SYSTEM/PROJECT/PRODUCT: Helios

HELIOS COMPATIBILITY

Issue	Change Ref	Date
1	-	25/03/2002
2	TS001076	18/07/2002
3	TS001142	11/02/2003
4	TS002501	04/05/2005

Top Aspect and Plastic Mounting Brackets

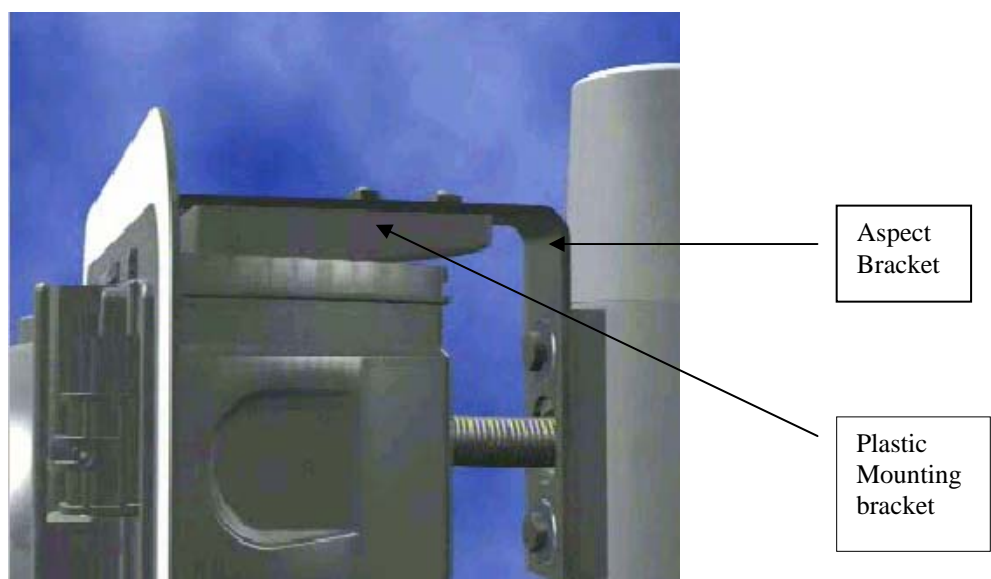
Early 1 aspect, 2 aspect and 3 aspect brackets were made of 5mm material and along with the 4 aspect mounting bracket had an 18mm slot for connecting to the plastic head mounting brackets (667/2/30052/003). Later 1 aspect, 2 aspect and 3 aspect brackets were made of 6mm material and the slot for connecting to the plastic head mounting brackets was reduced to 11mm for the 1, 2, 3 and 4 aspect brackets. Along with this change the plastic mounting brackets were changed. If an original bracket requires changing, then both the aspect bracket and the plastic mounting bracket need changing.
